Project  
**East West Rail  
(Western Section)  
Phase 2**

Drawing Title  
**PASSING PLACE A3\_P\_1  
GENERAL ARRANGEMENT**

### Stage 2 Road safety audit response report

### Offline Highways Passing Places – Package 2 – Oxfordshire (A3 Marsh Gibbon – Compound Access)

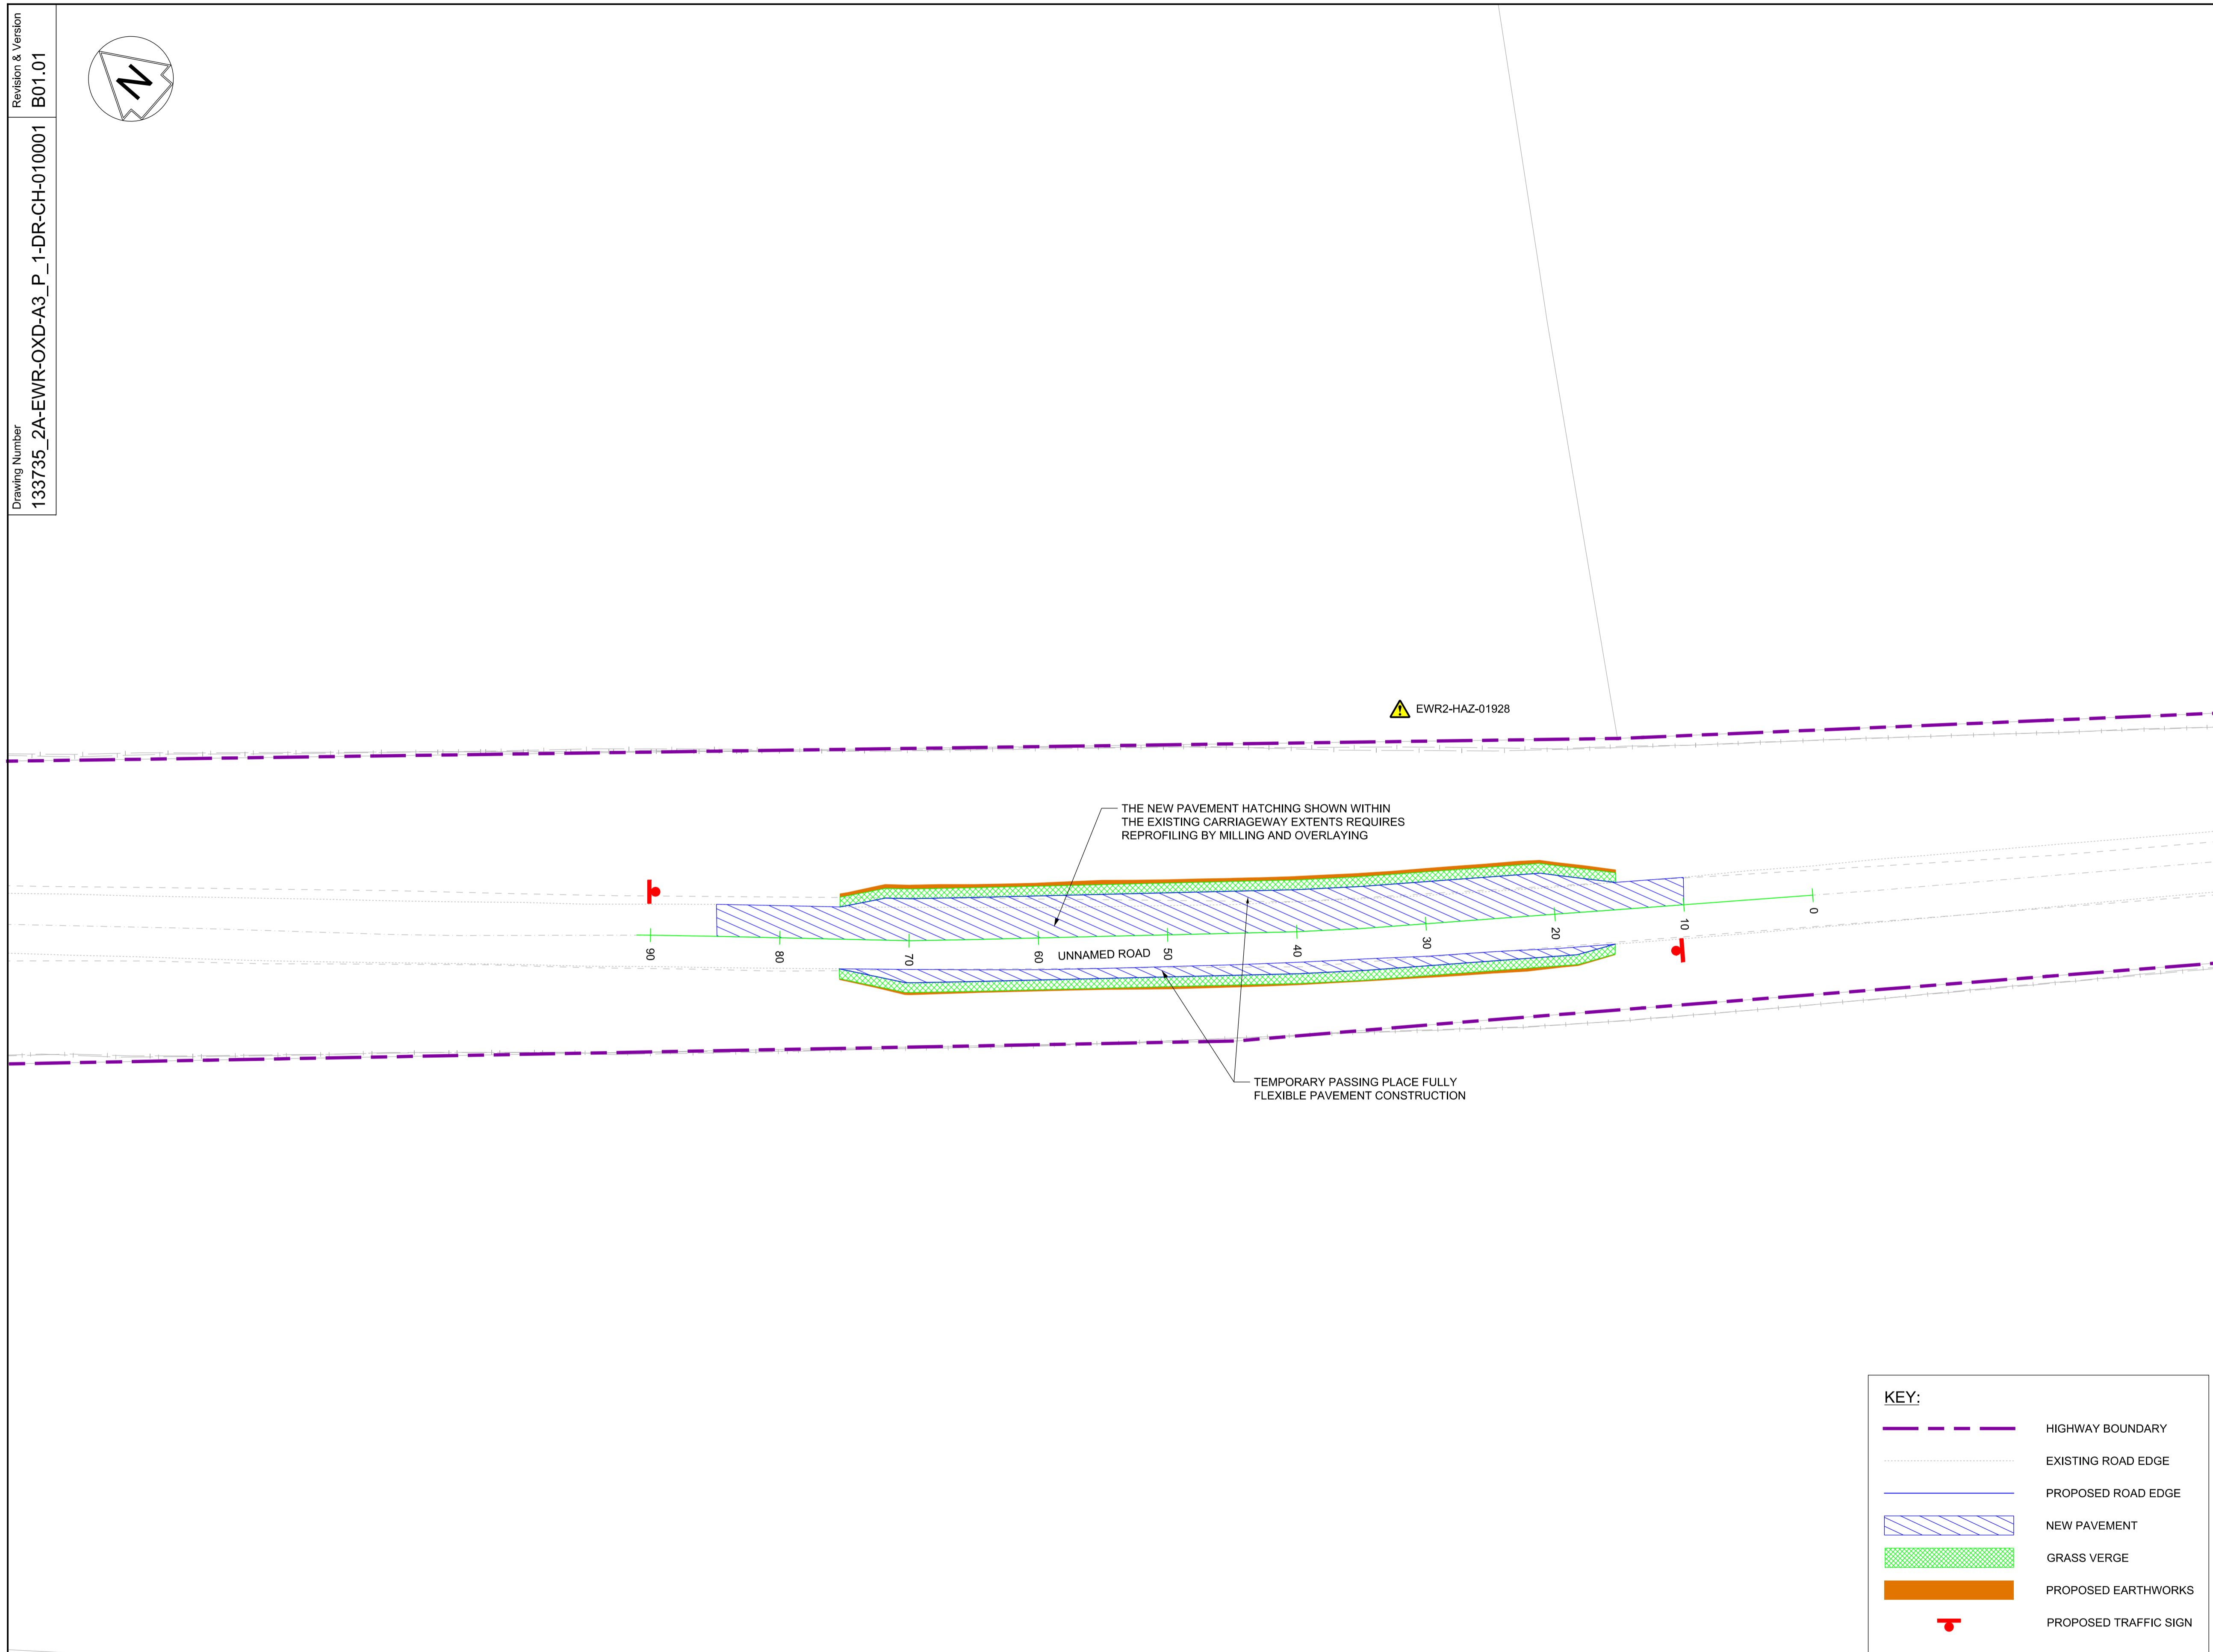
**Location:** Passing Places A3-P-1, A2-P-1, A3-P-2 and A3-P-8.  
Unnamed Road (towards Mill Road).

Driver accessibility to passing places is obstructed by trees, and in some locations, signposts situated in the verge. There is a risk that drivers may collide with the trees on entry/exit of the passing place. Also, drivers' forward visibility is restricted by the location of these trees and as such, drivers of construction vehicles may not be aware that they should wait and might proceed, increasing the risk of side swipe collisions. Additionally, approaching drivers may not anticipate the construction vehicle leaving the passing place, leading to side swipe or head on collisions.

Obstructions should be removed from the verges.

RSA Ref	Location	RSA Problem	RSA Recommendation	Design Team Response	Network Rail Response	Agreed RSA action
2.1	Passing Places A3-P-1, A2-P-1, A3-P-2 and A3-P-8. Unnamed Road (towards Mill Road).	<b>Obstructions in verge increase risk of collision</b> Driver accessibility to passing places is obstructed by trees, and in some locations, signposts situated in the verge. There is a risk that drivers may collide with the trees on entry/exit of the passing place. Also, drivers' forward visibility is restricted by the location of these trees and as such, drivers of construction vehicles may not be aware that they should wait and might proceed, increasing the risk of side swipe collisions. Additionally, approaching drivers may not anticipate the construction vehicle leaving the passing place, leading to side swipe or head on collisions.	Obstructions should be removed from the verges.	<b>Accept the RSA problem and recommendation made by the RSA team.</b> The site clearance drawings note that vegetation clearance shall be undertaken to provide suitable visibility. There is also a note for the lifting of tree crowns to provide 5m clearance above ground level to the back of the proposed verge.	Accepted	Proceed as Design Team Response
